ADDENDUM NUMBER 2

**LINCOLN COMPLEX – BUILDING O O.A.R., LIBRARY SERVICES AND I.T.
RENOVATIONS
930-B Oak Street SE, Albuquerque, NM 87106
ALBUQUERQUE PUBLIC SCHOOLS**

APS RFP No. 21-031-RRR

Date of Issue: 12/7/2020

ROOF PLAN
A-109
SHEET ____ OF ____

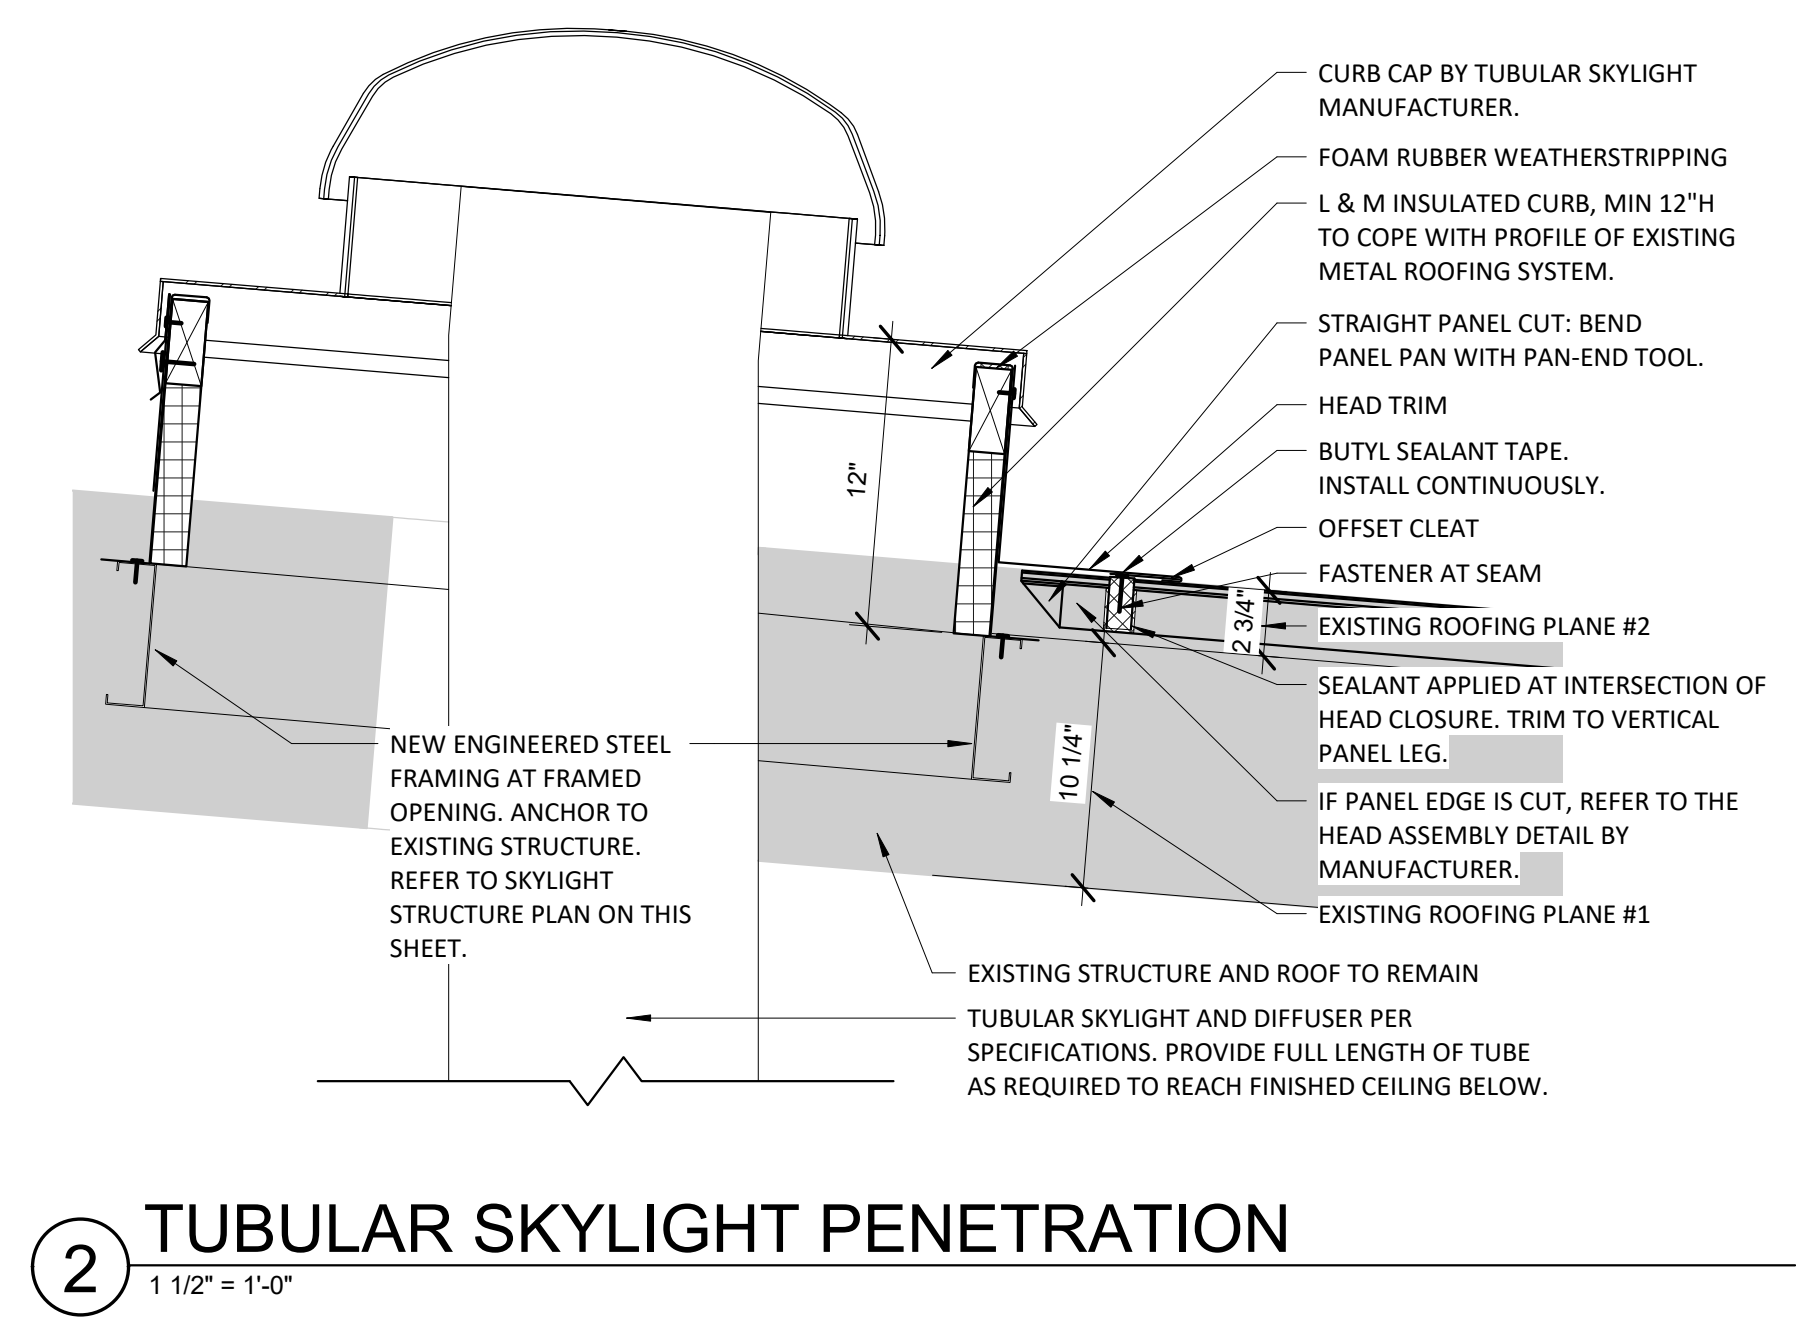
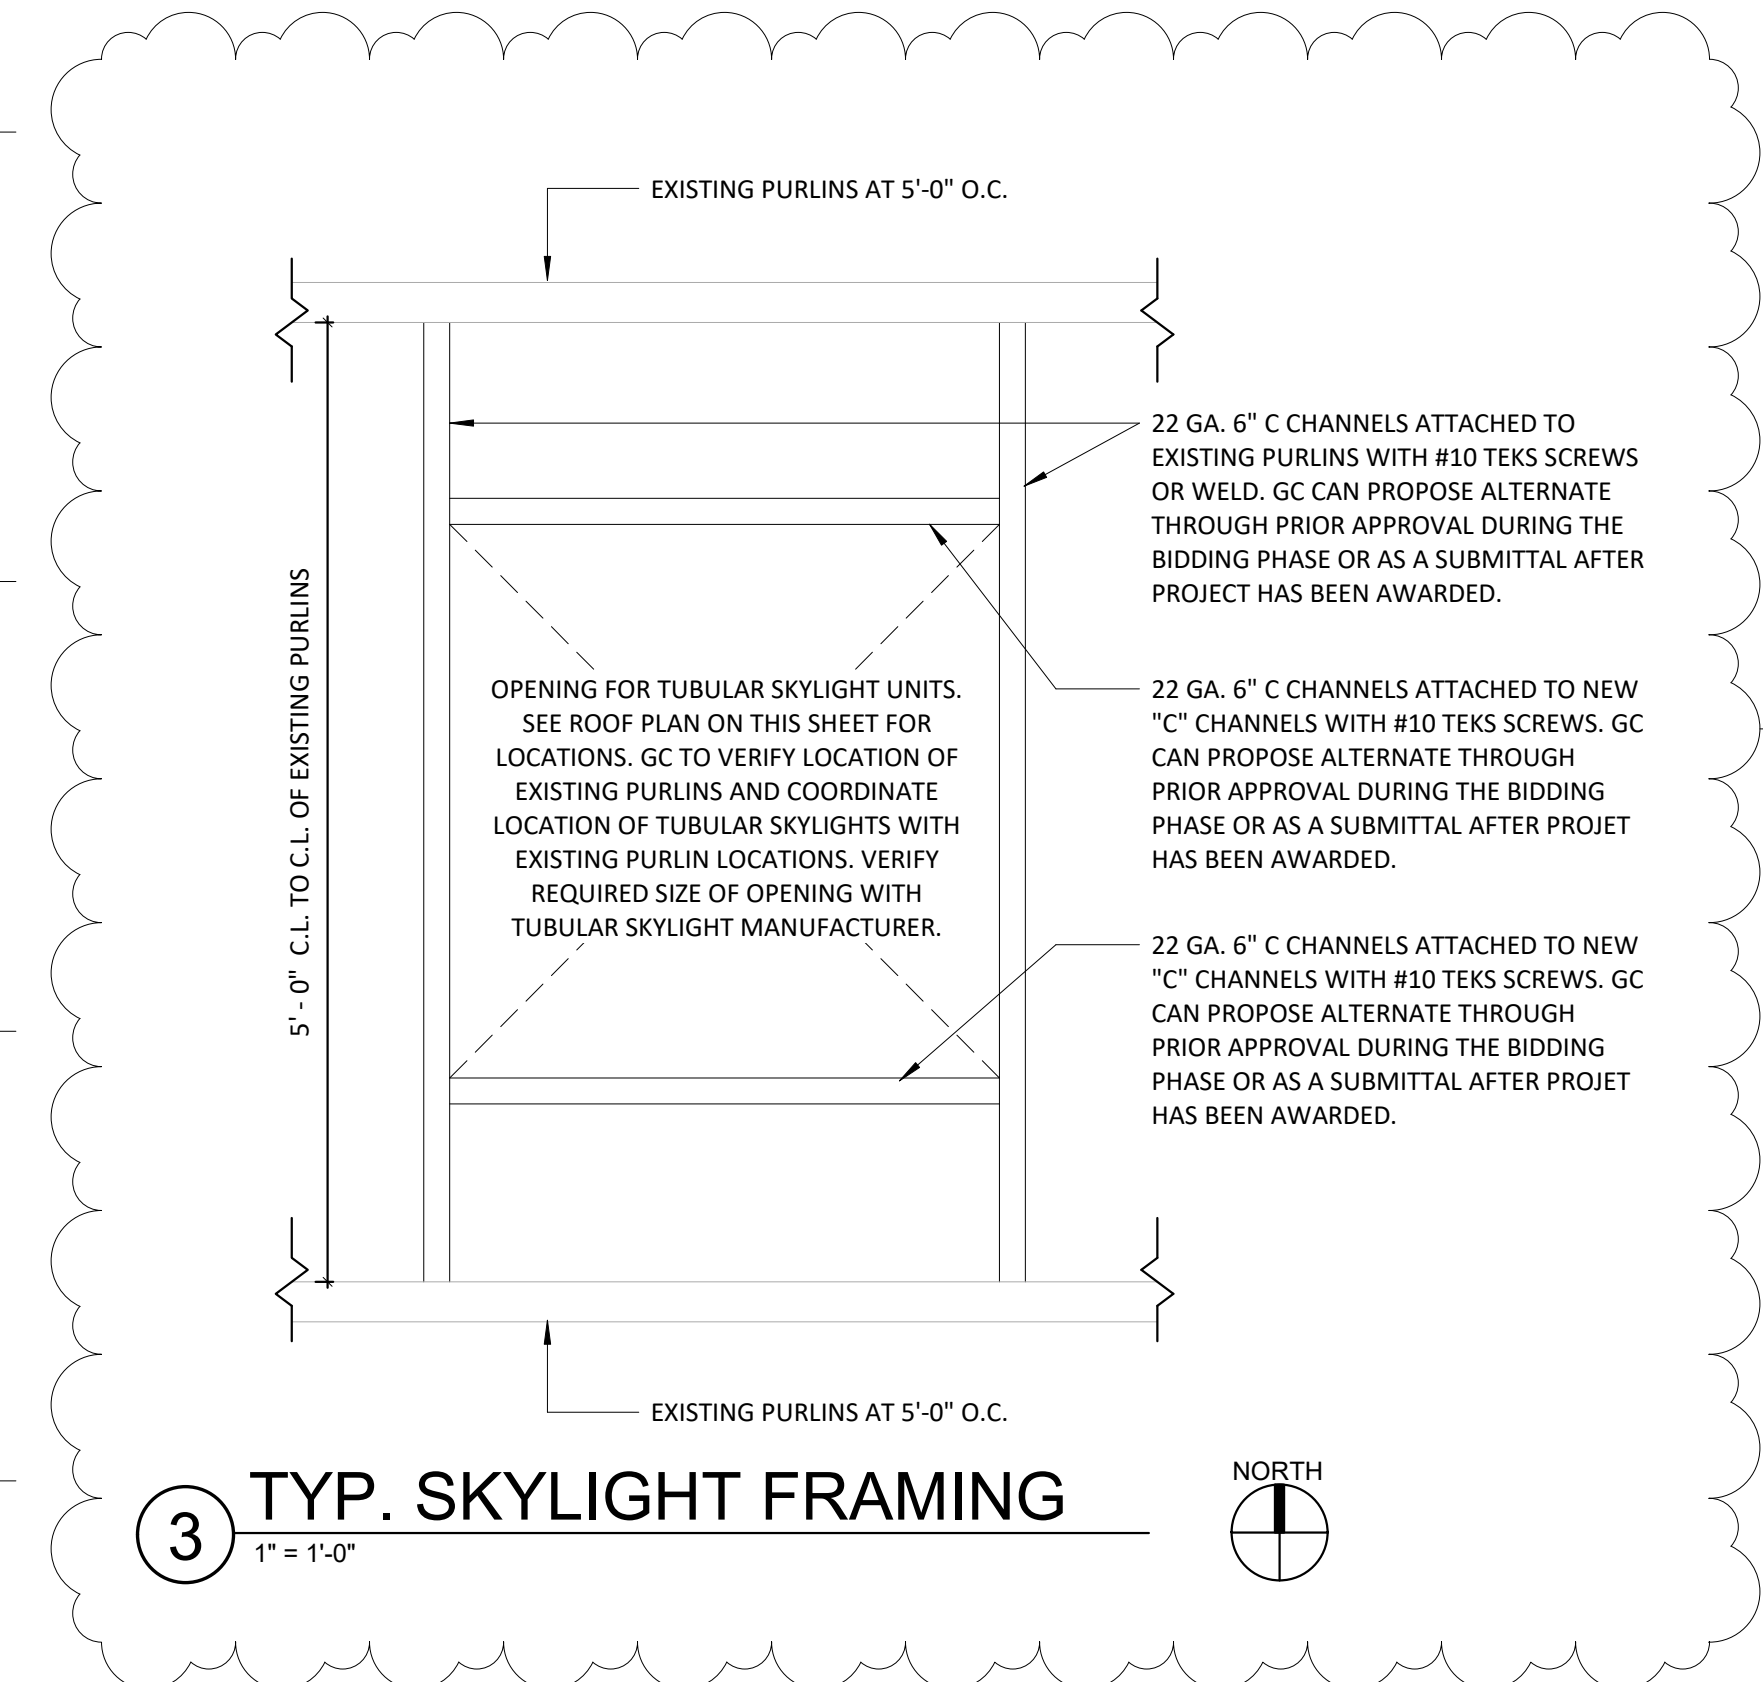
"There are two different scales on the AD sheets and on the roof plan A109. Which are correct?"

"Please provide existing roof structural drawings for skylight structure engineering and pricing."

- 1) Add "Typ. Skylight Framing", Detail 3/A-109 for structural framing members and connection of tubular skylights to existing roof structure. See attached A-109 "Revision 1" sheet.
- 2) Clarification for stainless steel corner guards from keynote 23 on sheet A-105 New Keyed Floor Plan and sheet A-801 Finish Plan. Please see attached A-105 for corrected keynote 23 for the change of 8' stainless steel corner guards to 6' stainless steel corner guards to match legend sheet A-801 Finish Plan.
- 3) Clarification for Door Schedule on Sheet A-601 and Door Types on Sheet A-602. See attached A-601 "Revision 1" and attached A-602 "Revision 1" for changes to Door Type "E" and Door Type "F" to now match on both sheets.

Answer: Both scales are correct. The scale on the roof plan shows the entire building. The scale for the AD sheets is for part of the building to show more detail as is the rest of the sheets only showing part of the building with the match lines.

Answer: There are no existing roof structural drawings available. Please see the attached A-109 "Revision 1" sheet for the new typical skylight framing members.

A-801

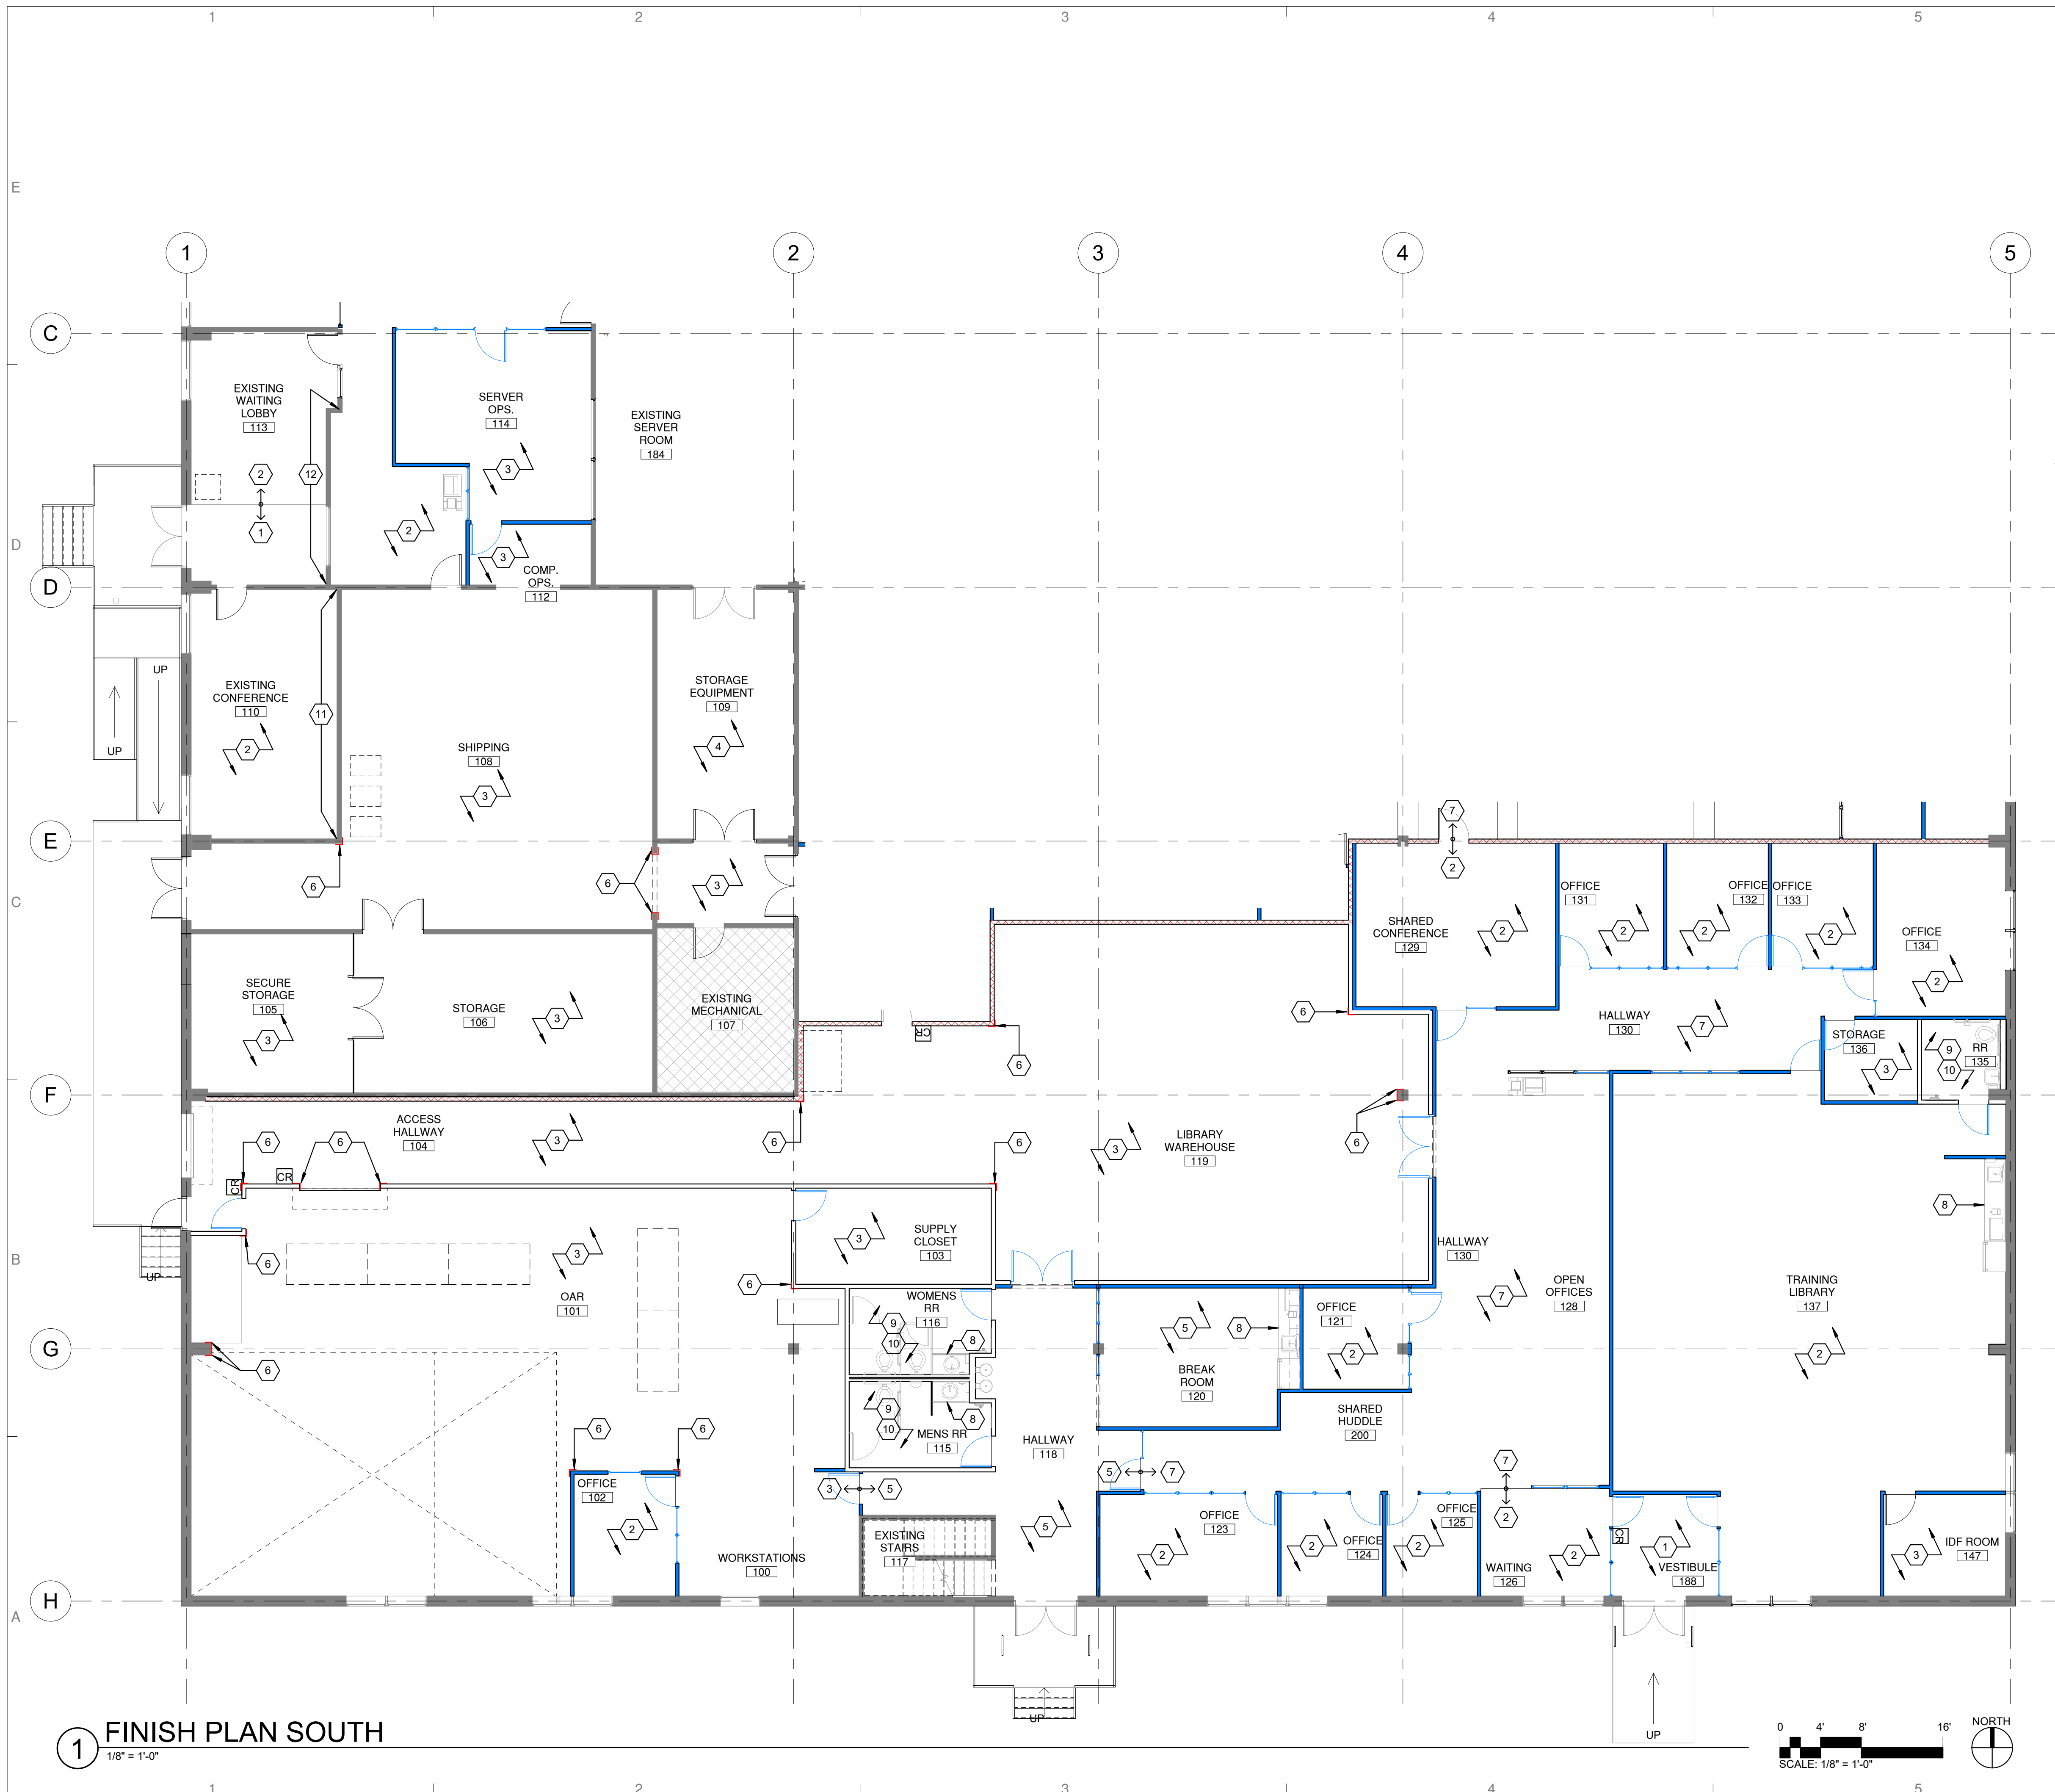
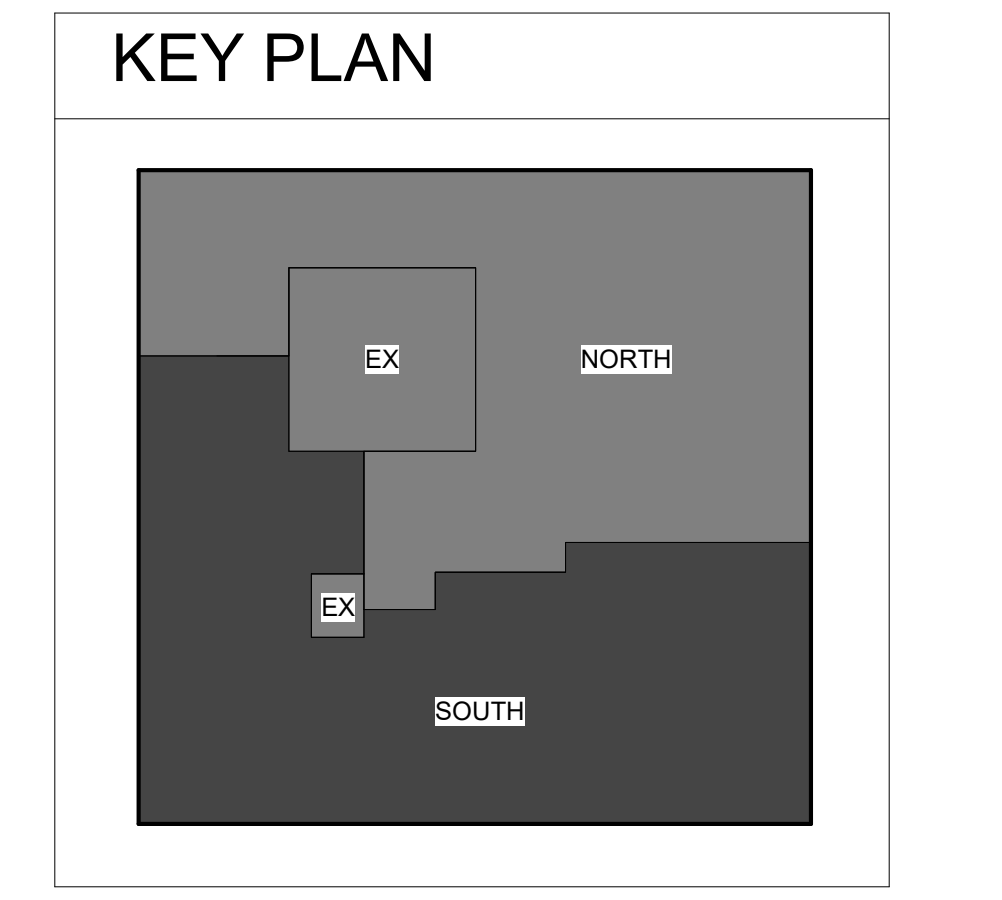
"Please clarify what walls will require base and what type."

Answer: All regular wall construction walls with gypsum board finish are to receive rubber wall base. Please refer to specifications section 09 65 13 for Resilient Base Accessories information. Please refer to attached A-801 and A-802 Finish Plans sheets for added general note about the wall base.

- L. ALL GYPSUM BOARD WALLS TO RECEIVE RUBBER WALL BASE BY JOHNSONITE, COLOR TO BE "T4 GATEWAY WG".
